City of San Antonio

Department of Development Services

Re: **Solana Ridge (Amended)**

MDP # 804-A

LOCAL "B"
NOT TO SCALE

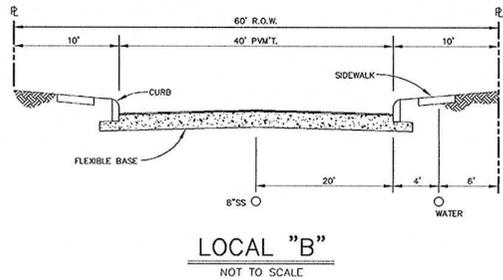
4. Construction of an internal Local “B” system. Local “B” design parameters consist of 60-feet of ROW and 40-feet of pavement (Table 506-3). The proposed Local “B” system shall have no houses fronting as shown in the submitted MDP.

MASTER DEVELOPMENT PLAN
for
SOLANA RIDGE SUBDIVISION

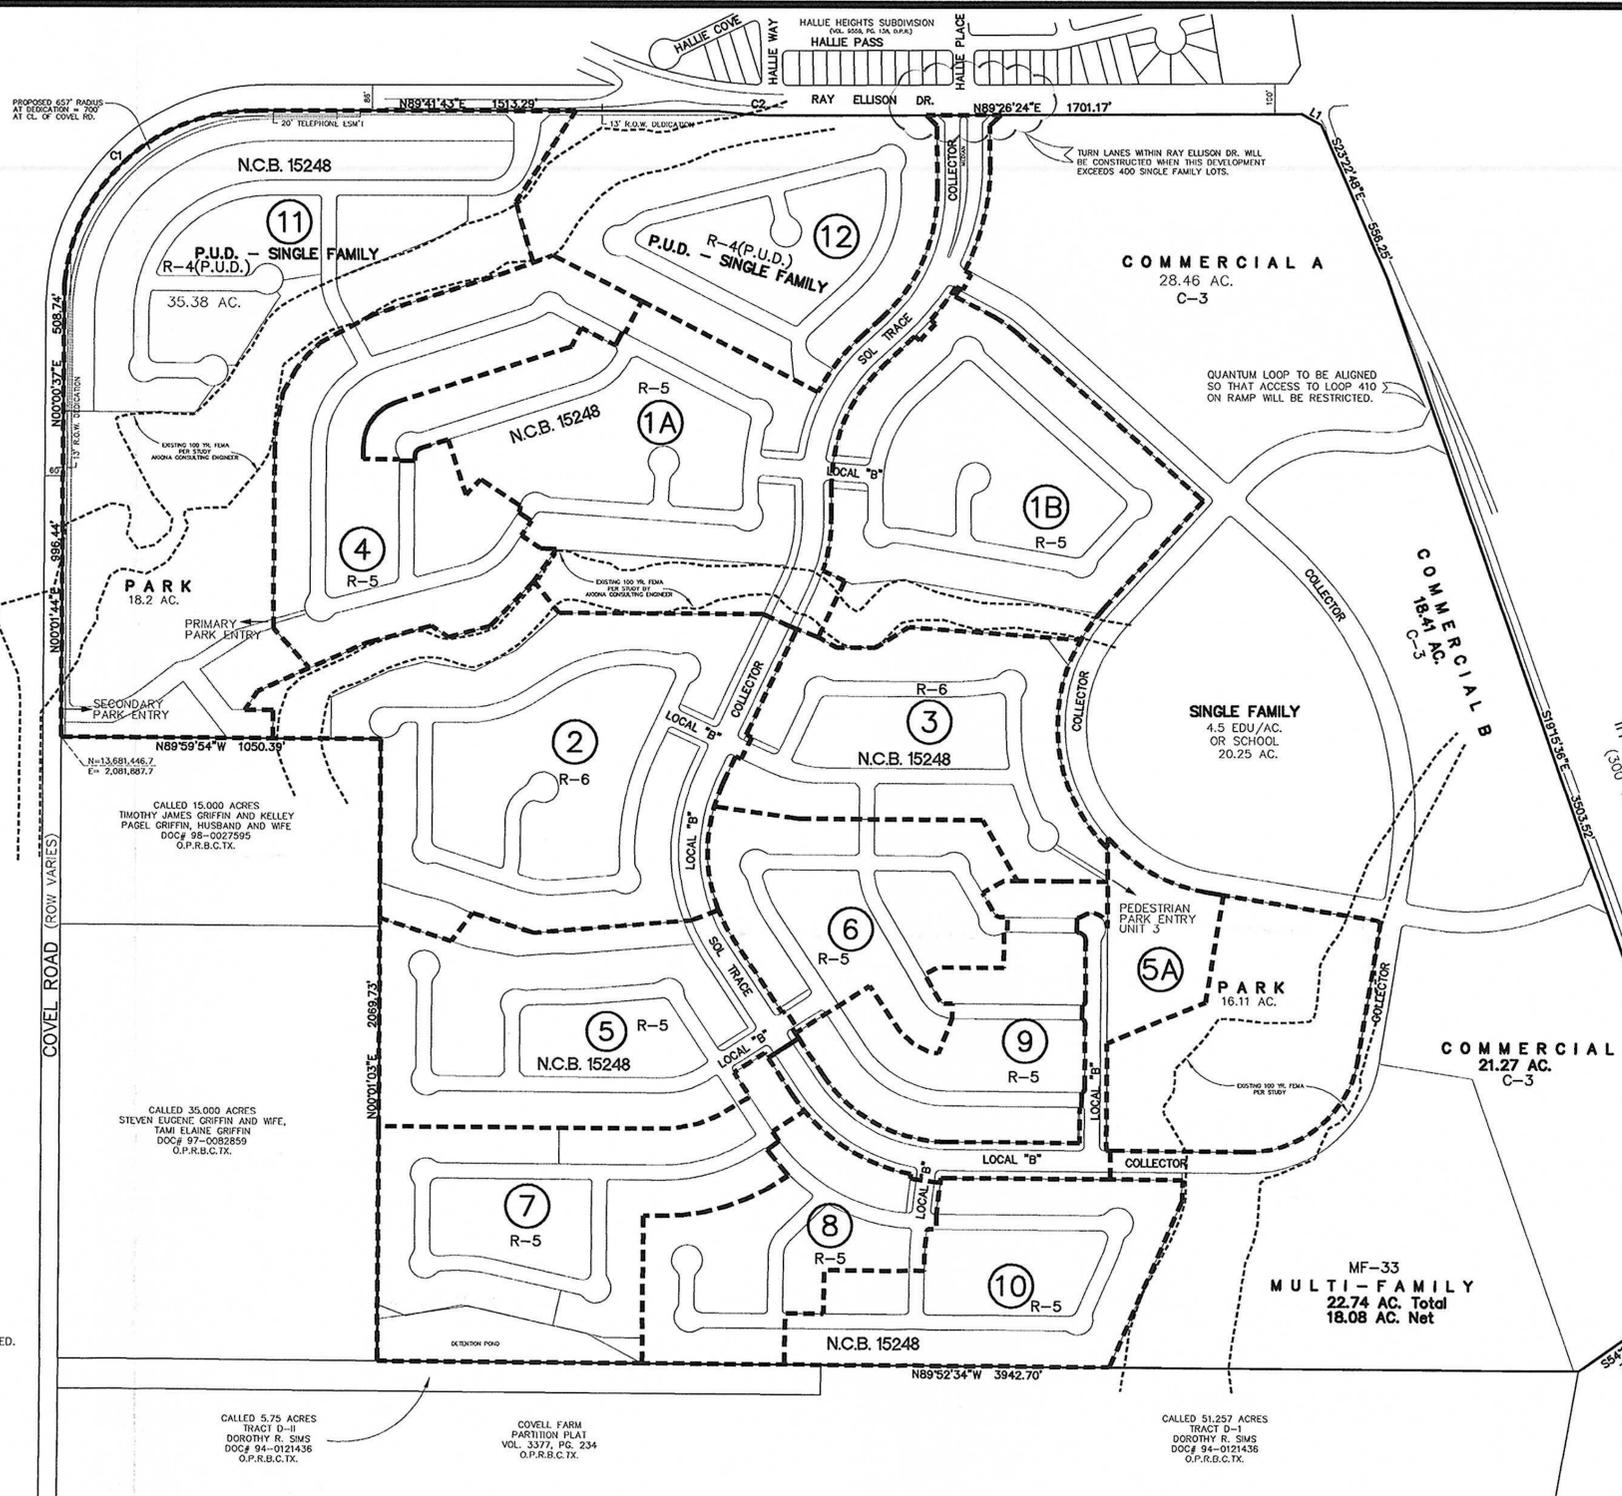
In consideration of public safety and convenience, excessive grades by reason of topography should be avoided in street layouts and arrangements:

The acceptance of this **Master Development Plan # 804-A** is confined to the boundary limits of the site. Any projection(s) of future roadways outside the boundaries does not infer any set alignment of future roadways. All major arterials and streets shall follow all regulations. It will be expected that you will plat all of the property depicted in your Master Development Plan (MDP), to include floodplains, drainage areas and open space.

- The following on-site improvements as well as improvements along the project limits are necessary and shall be provided by the developer at the time of platting for the Solana Ridge Development, at no cost to the City of San Antonio:

1. Ray Ellison Drive - The Developer shall dedicate 43 feet of ROW (Ordinance 98282, October 2, 2003 Major Thoroughfare Plan (MTP)) from the centerline of Ray Ellison Drive (Secondary Arterial Type A – Uniform Development Code (UDC) 35-506, (g), (2)) adjacent to this proposed project. The total length of property frontage is approximately 2200-feet.

2. Covell Road - The Developer shall dedicate 43 feet of ROW (Ordinance 98282, October 2, 2003 Major Thoroughfare Plan (MTP)) from the centerline of Covell Road (Secondary Arterial Type A – Uniform Development Code (UDC) 35-506, (g), (2)) adjacent to this proposed project. The total length of property frontage is approximately 3700-feet.

3. Construction of an internal collector street system. Collector street design parameters consist of 70-feet of ROW and 44-feet of pavement (Table 506-3). The proposed collector street system shall have no houses fronting (UDC 35-515, (c), (4)).

5. All Roadways shall conform to UDC 35-506 (c), (1), Table 506-1: Functional Classification System Description.
 6. The developer shall be responsible for upgrading the intersection of Ray Ellison Drive and the Collector Street. This includes a sufficient left-turn storage lane on westbound Ray Ellison Drive, with a bay taper and transition (UDC - 35-506, (m), (2) and a right-turn deceleration lane (eastbound Ray Ellison Drive) with a storage lane and bay taper as it relates to the submitted TIA traffic counts, (UDC - 35-502 (a)(7), subsection C. Design and construction shall be coordinated with Development Services TIA Division.

7. All access driveways shall follow UDC 35-506 (r) Access and Driveways.
8. All access driveways/roadways shall provide clear sight distance along Ray Ellison Drive, Covell Road and Loop 410 Frontage Road in order to provide adequate obstruction free viewing distances for approaching traffic. All signage, landscaping, and improvements shall be selected and located so as to not block these clear sight distance areas.

It should be understood that the submitted TIA concurrent with the proposed Solana Ridge MDP is a conceptual plan and therefore this document does not represent an approval for the internal street plan. All streets and access driveways shall follow UDC 35-506 and the street network shall be planned in order to provide safe and efficient movement of traffic to and from, within and past, the proposed development, while minimizing the impact to non-site trips. UDC 35-506 will be implemented at the time of platting.
